# Access Compliance Report

## Public Rights-of-Way

### (Curb Ramps)

Intersection ID: 24485	Main Street: CAMAROSS_DR	Cross Street: SAINTFIELD_PL	Location: SE
ADA ID: 1B6D70E44690	Ramp Type: Perp	Initial Pass/Fail: Fail	Overall Compliance: No
		Severity Score: 12.5

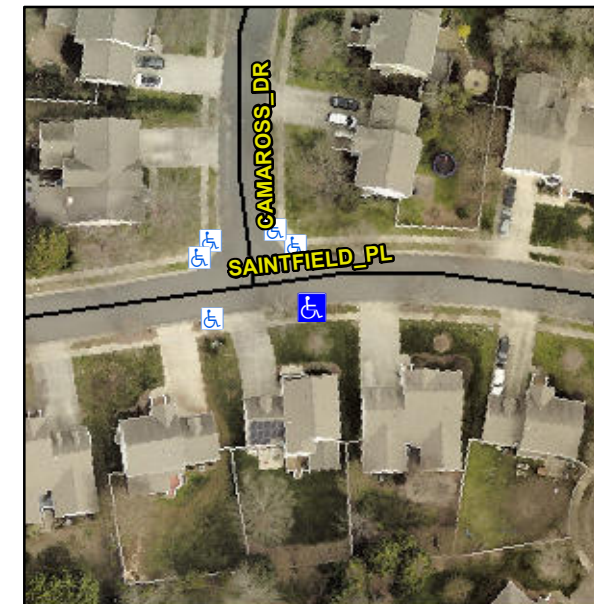
**Not Found, R304.2.2**

Compliance	Description	Data	Compliance	Description	Data
N/A	Ramp Length (in)	48.0	No	Ramp Slope (%)	8.7
Yes	Ramp Width (in)	48.0	Yes	Ramp XSlope (%)	0.4
N/A	Flare Type LT	N/A	N/A	Flare Type RT	N/A
N/A	Flare Slope LT (%)	N/A	N/A	Flare Slope RT (%)	N/A
N/A	Flare Traversable LT?	N/A	N/A	Flare Traversable RT?	N/A
N/A	Landing Length (in)	N/A	N/A	DWS Provided?	N/A
N/A	Landing Width (in)	N/A	N/A	DWS Contrast?	N/A
N/A	Landing Slope (%)	N/A	N/A	DWS Length (in)	N/A
N/A	Landing X Slope (%)	N/A	N/A	DWS Full Width?	N/A
N/A	Landing Curb? (Y/N)	N/A	N/A	DWS Offset (in)	N/A
N/A	Shared Landing?	N/A			
N/A	Gutter Ponding?	N/A	N/A	Gutter Slope (%)	N/A
N/A	Gutter Lip Ht (in)	N/A	N/A	Gutter X Slope (%)	N/A
N/A	Painted X Walk1?	No	N/A	Painted X Walk2?	N/A
	X Walk 1 Direction	To N		X Walk 2 Direction	N/A
N/A	X Walk 1 Width (in)	N/A	N/A	X Walk 2 Width (in)	N/A
	X Walk 1 Slope (%)	2.8		X Walk 2 Slope (%)	N/A
	X Walk 1 X Slope (%)	1.6		X Walk 2 X Slope (%)	N/A

**Remove & Replace Entire Ramp.**
